Delegated Report

Approval of Details Application

Application no: 20260382

Location: 20 Stone Street Gravesend Kent DA11 0NP

On drawing no. P121 Separating walls (Between flats and communal areas) there is a detail shown entitled 'Detail D Internal Walls (Non-separating) bedrooms and bathrooms' which is as follows:

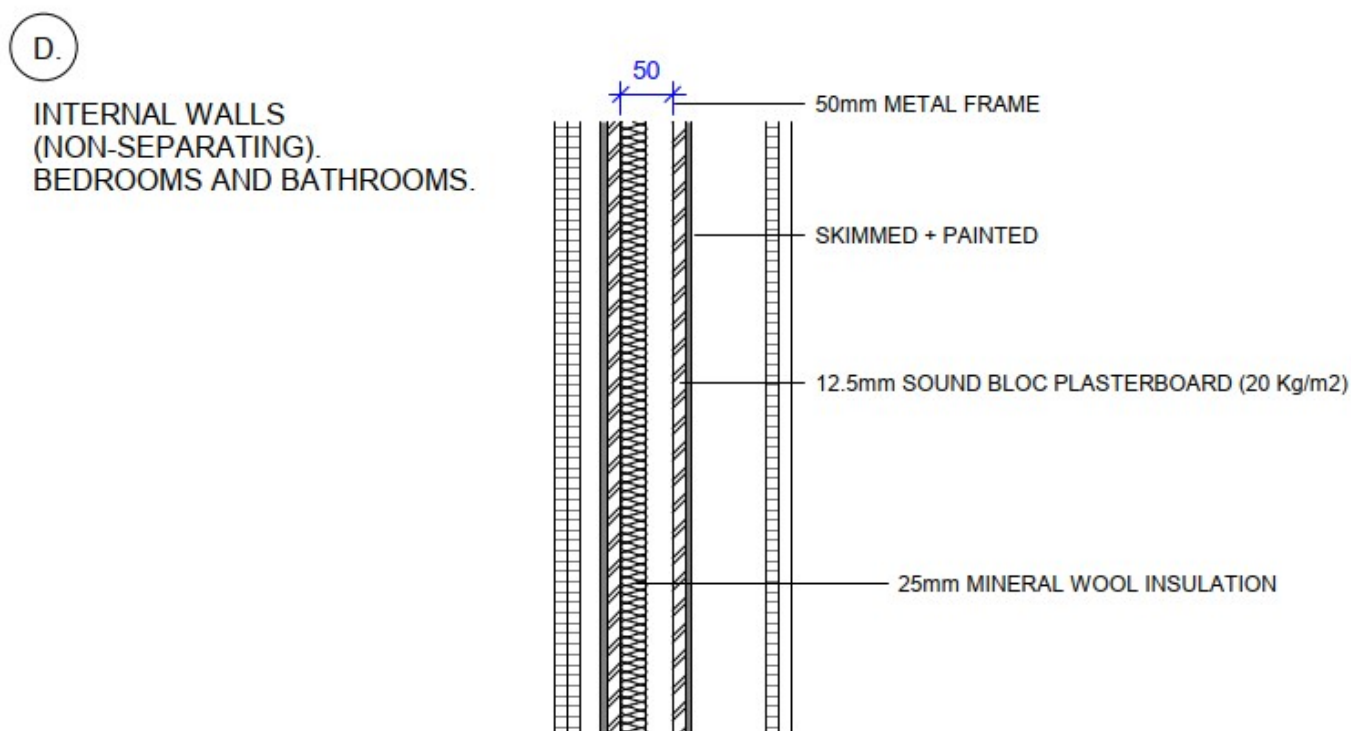
This shows a segment of the proposed internal wall for the new shower rooms however and does not show the whole wall and how it would relate to the existing walls/ceilings/cornices/skirting boards. On drawing no. P202 Rev. 1 'Proposed Second Floor Plan New Walls' there is some more information shown in terms of an acoustic ceiling and with an annotation stating that there is no existing coving on site although that is not true as there is cornicing still present in the building. The details are generic and it is not known where they are in relation to the whole area of the flat. The condition requires full details of **all** new internal partition walls including plans and sections of the intersections with existing walls/ceilings/cornices/skirting boards, not just one small generic detail where it is not known even where it is. This has not been submitted and therefore insufficient detail has therefore been submitted for condition 3.

Please see below what is proposed in this approval of details application in terms of the removal of the dividing walls at first and second floor levels – note the new wall fabric which is not what was approved:

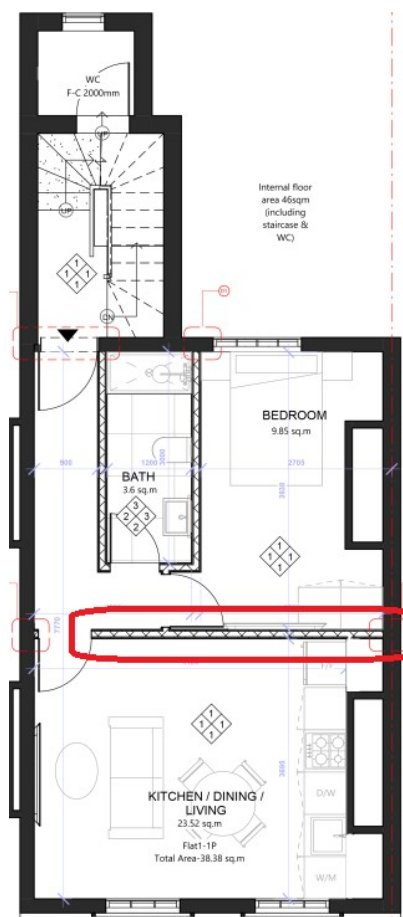
In the submitted details, however, it is therefore clear that these show the removal of the entire section of the dividing wall between the front and back rooms at first floor level and the removal of the remaining parts of the wall at second floor level.

The removal of the entire dividing wall between the front and rear rooms at first floor level and the remaining sections of the wall at second floor level does not have approval in the approved application and is new work proposed that would require Listed Building Consent. It cannot be dealt with under this approval of details application but in any case, such a proposal would not be acceptable.

It would result in the removal of the entire dividing wall at first floor level and the removal of the remaining parts of the wall at second floor level. As the Conservation Officer points out, the removal of the wall would also result in the loss of ceiling cornices, which he states must be retained and remain visible and that they survive on the first floor level. He also notes how the proposed dropped ceiling which is proposed will result in the loss of ceiling cornices and so an alternative proposal needs to be designed where the cornices remain visible.

The Conservation Officer advises that the drawings need revising to show the retention of the remaining parts of the wall and all cornices.

On drawing nos. P201 Rev. 1 'Proposed First Floor Plan New Walls' and P202 Rev. 1 'Proposed Second Floor Plan New Walls' an acoustic ceiling is shown as follows:

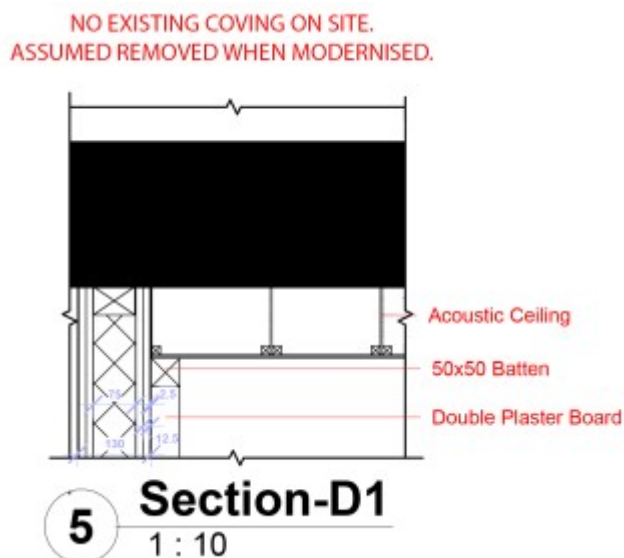
As stated above in relation to the new internal wall condition no. 3, the Conservation Officer advises that such a dropped ceiling would not be acceptable as the proposals would result in damage or harm to the appearance of the ceiling cornices that exist at first floor level and the design solution needs to be reconsidered to take this into account. An acoustic floor is proposed which the Conservation Officer makes

On drawing no. P06 'Proposed Elevation 1', it shows a new rainwater pipe down the centre of the rear elevation from ground to eaves level.

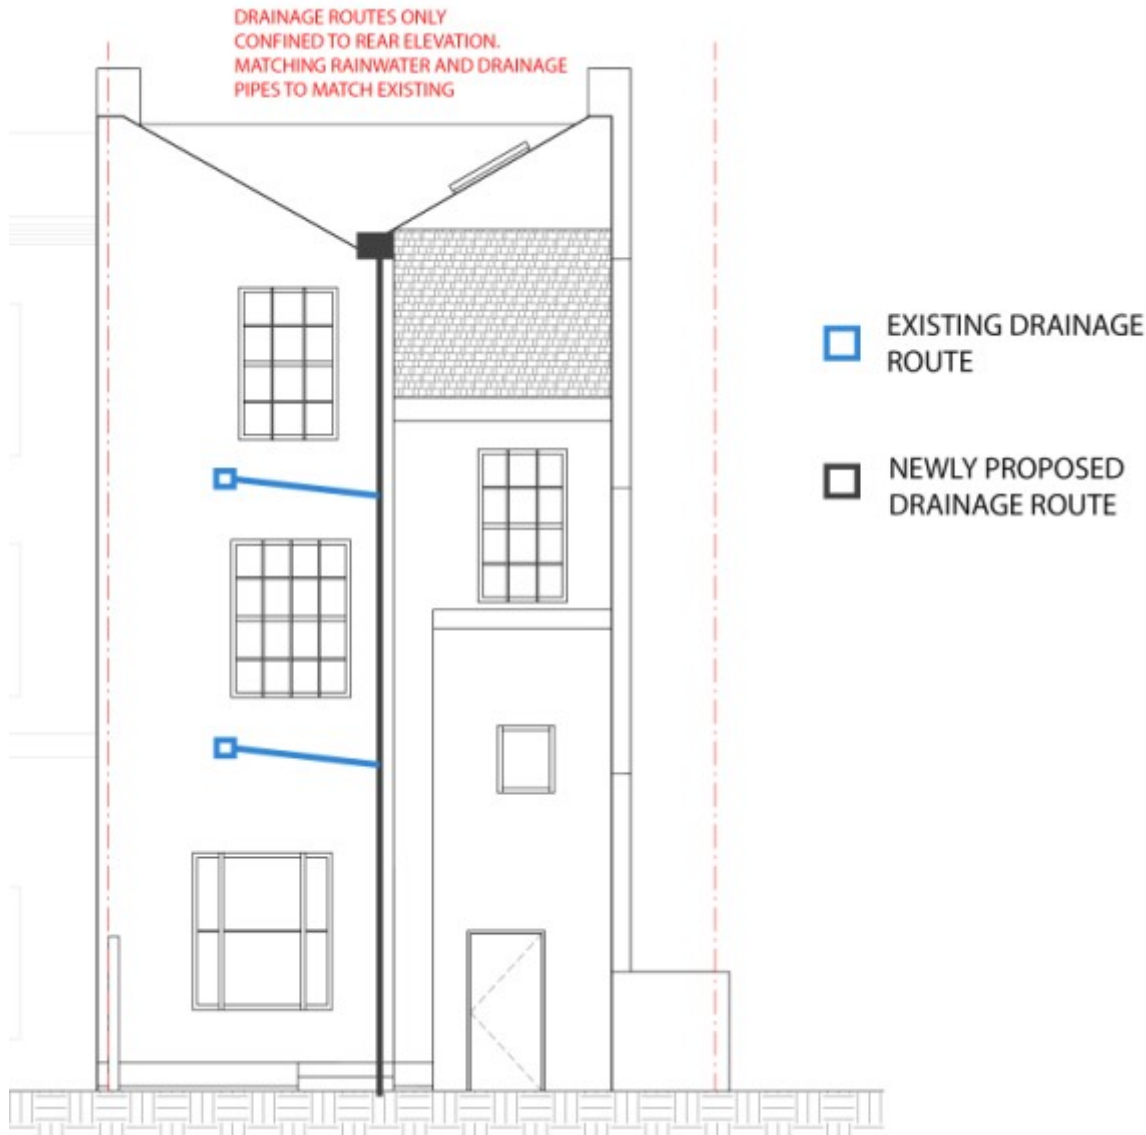
Although we know the location of the pipe there is no detail of what it would be made of, only that it would match existing which is not sufficient as full details of the location, appearance and finish of all pipework was requested. It is also confusing/contradictory as the blue is meant to be 'existing drainage route' but as seen in the photo in the submitted document, they do not exist.

There are no details of vents at all, but it is not clear if that is actually because none are proposed as that is not specifically stated. The two shower rooms at first and second floor levels would presumably need vents as they would both be internal rooms with no windows and the extraction systems for the cookers in each kitchen would need vents also.
